Re: Comments on Draft Environmental Impact Report for the Excelaron/Mankins Conditional Use Permit (SCH No. 2009021025/DRC2009-00002/ ED09-039)

The project evaluated in the DEIR includes development to establish oil production of up to twelve oil wells over four phases. The project is located 12 miles southeast of the City of Arroyo Grande, in the South County Inland and Huasna-Lopez planning areas.

Diagram 1: A simple geometric argument demonstrates that a vertically drilled well with an effective recovery radius of 150 feet from the wellbore can only access 1.6 acres of sub-surface mineral rights

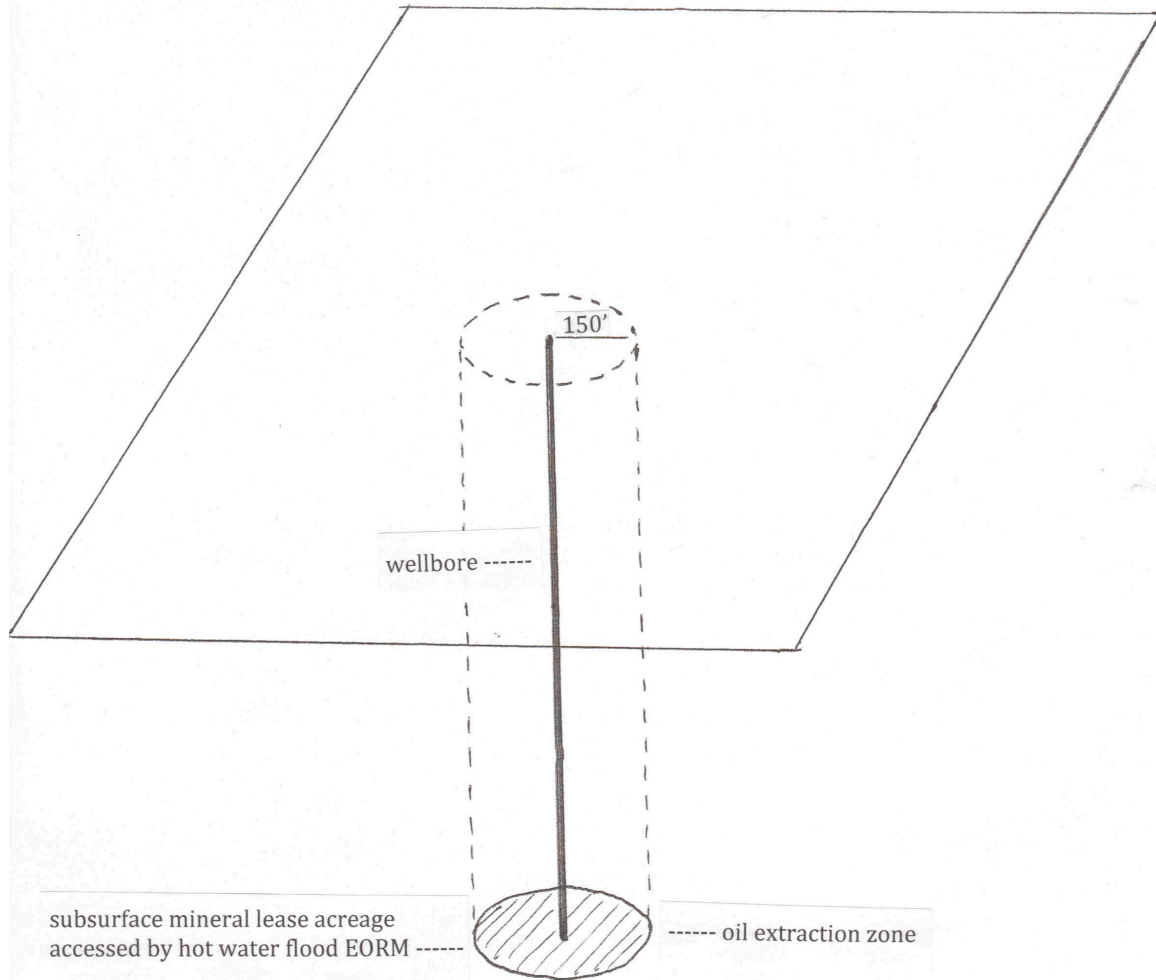
Section 2.2.3 of the DEIR states that the hot water flood EORM (Enhanced Oil Recovery Method) proposed by Excelaron is only effective to a depth of 2,000 feet and a radius up to 150 feet from the wellbore. On page 2-12 it states that the initial four wells will be vertically drilled. A simple geometric argument demonstrates that a vertically drilled well with an effective recovery radius of 150 feet from the wellbore can only access 1.6 acres of sub-surface mineral rights (Diagram 1):

$$\begin{aligned} \text{horizontal cross sectional area} &= \pi * (\text{radius})^2 = 3.14 * (150 \text{ feet})^2 \\ &= 70,650 \text{ ft}^2 = 1.6 \text{ acres} \end{aligned}$$

The proposed twelve wells, if all vertically drilled, could only access approximately 19 acres of sub-surface mineral rights. This is in contrast with the stated project objective of extracting oil from at least 160 acres of sub-surface mineral rights and possibly a much larger area. To achieve the stated project objective, many more wells would be needed, or the proposed twelve wells would need to be drilled horizontally for thousands of feet (Diagram 2).

The project description, therefore, must be revised consistent with the stated project objective to access and extract oil from the entire 160 acres of sub-surface mineral rights or even the greater area over which Excelaron's parent companies have acquired mineral rights.

Diagram 3: Mogul Energy’s development plan for the Huasna Oilfield, posted on their website in 2009 shows 6 horizontal wells producing oil from 15 vertical hot water injection wells.

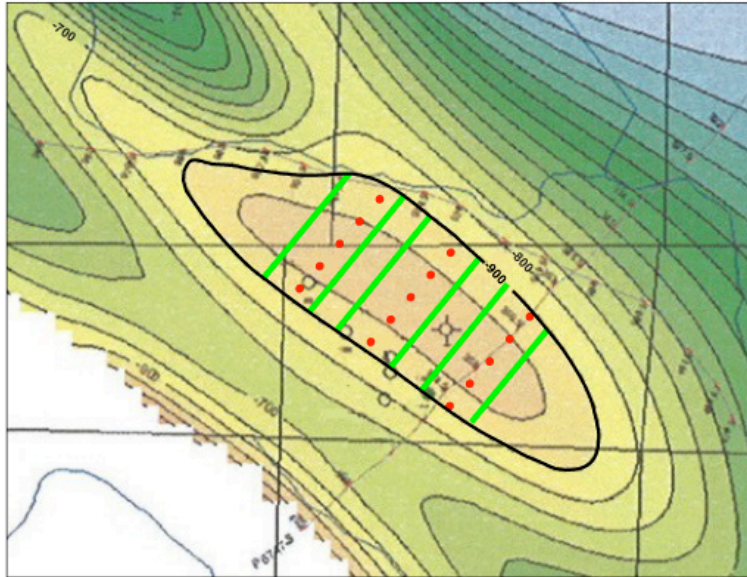
In February, 2009, Mogul Energy, a 40% partner in Excelaron at the time, posted a diagram on their website in which 6 horizontal wells would produce oil from 15 vertical hot water injection wells (Diagram 3 and Appendix D). At a public informational meeting hosted by Excelaron on July, 13, 2011, United Hunter Oil CEO, Art Hallerman, acknowledged the Mogul plans. "He even acknowledged that he's fixed up the veritable engineering mess that Mogul Energy left before he took over." (C. Rigley, "We'll Get Back to You," New Times SLO, July 21, 2011) Although this diagram may have represented a "veritable engineering mess," it nevertheless represents a plan that was much larger and different in its description from the plan being represented to the county at the time.

The EIR must be revised to seriously consider additional wells or other extraction methodologies that the applicant could reasonably be expected to employ in order to accomplish its stated objective of accessing and extracting oil reserves over 160 acres.
